AFFIDAVIT OF JOHN S. KORENY

NOVEMBER 11, 2008

In the Matter of the Petition for Delivery Call of A&B Irrigation District for Delivery of Ground Water and for the Creation of a Ground Water Management Area

The purpose of this testimony is to rebut information in the Pocatello Rebuttal Report dated August 27, 2008 and information in the Pocatello Sur-Rebuttal Report dated September 16, 2008 concerning the Unit B irrigation diversion requirement calculations. Both reports were prepared by Mr. Greg Sullivan of Spronk Water Engineers, Inc.

Figure 1 Comparison of Unit B well pumping capacity in 2007 to the 0.89 miner's-inch/acre irrigation diversion requirement in the A&B Expert Report. This shows that about 110 Unit B well systems (or 76%) cannot meet the irrigation diversion requirement.

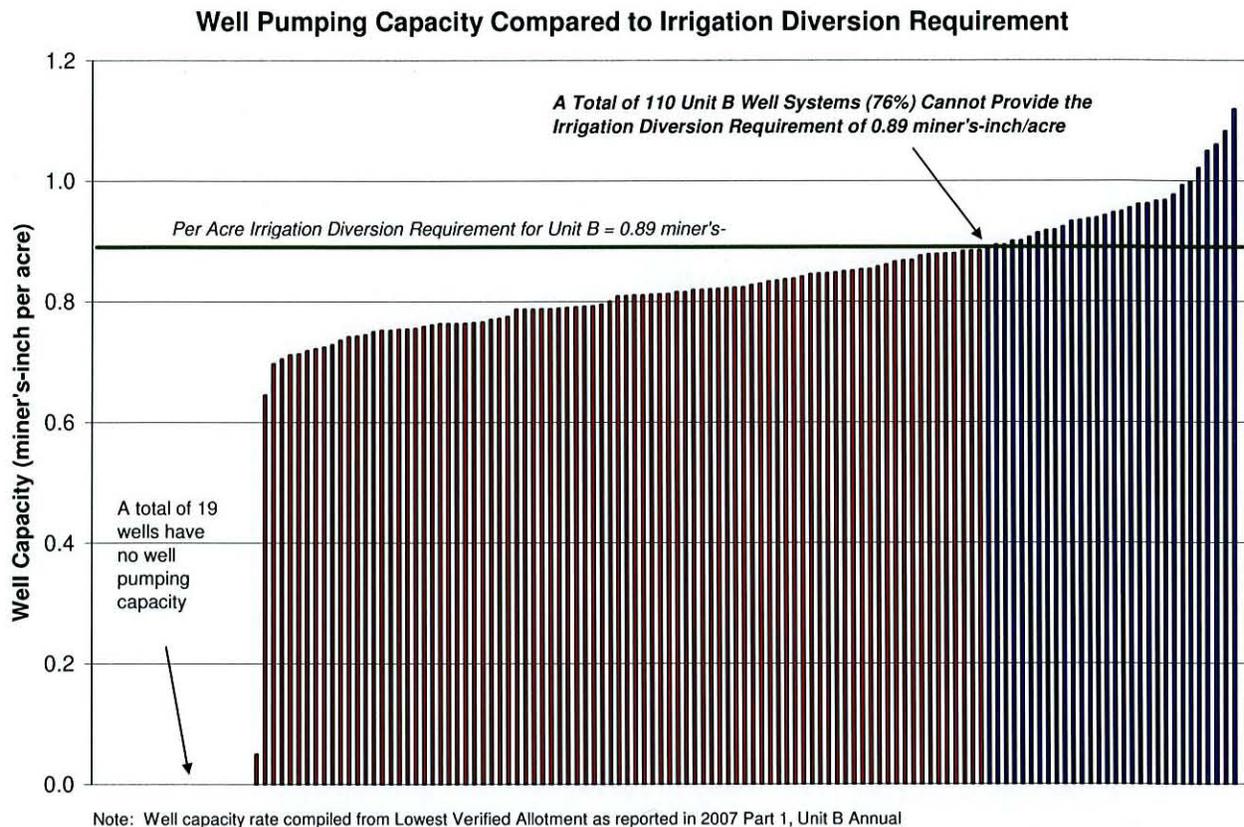
The Pocatello Rebuttal Report by Mr. Greg Sullivan dated August 27, 2008 criticizes the irrigation diversion requirements analysis in the A&B Expert Report. Mr. Sullivan criticized the fact that the full well pumping capacity was not used when comparing supply and demand to evaluate Unit B shortages. Mr. Sullivan concludes that the A&B Experts shortage estimate is too large because the full well pumping capacity requirements were not assumed to be available. (See pages 16 to 17 of Sullivan Rebuttal Report).

Mr. Sullivan is incorrect for two reasons. First, most Unit B wells do not have sufficient pumping capacity to meet the peak irrigation diversion requirements. **Figure 1** compares the current well pumping capacity to the average peak (July) irrigation diversion requirement rate of 0.89 miner's-inch/acre computed in the A&B Expert Report (A&B Expert Report, July, 17, 2008, Table 4-13, pg. 4-47). **Figure 1** compares the most-recent Unit B well pumping capacity¹ to the 0.89 miner's-inch/acre irrigation diversion requirement rate computed in the A&B Expert Report. **Figure 1** shows that about 110 Unit B well systems (or about 76 percent of all Unit B well systems) can not meet the A&B Expert's irrigation diversion requirement of 0.89 miner's-inch/acre. This shows that Unit B well pumping capacity is insufficient to meet the irrigation diversion requirement.

¹ The Unit B well pumping capacity data was compiled from the Unit B Annual Reports under the Lowest Verified Allotment column in Part I of the report. This is the correct statistic to evaluate well capacity because it reports on the capacity of wells to pump during the middle of the irrigation season when ground water levels are lowest and irrigation demand is highest.

Second, it is incorrect to assume that an individual Unit B well system can pump at full capacity all of the time. There are many periods during the irrigation season when irrigation can not occur to accommodate agricultural practices needed for specific crops (such as fertilizer application, tilling, seed planting, germination, herbicide/pesticide application, harvest, etc). This is why the method utilized in the A& B Expert Report uses the actual pumping records from the well.
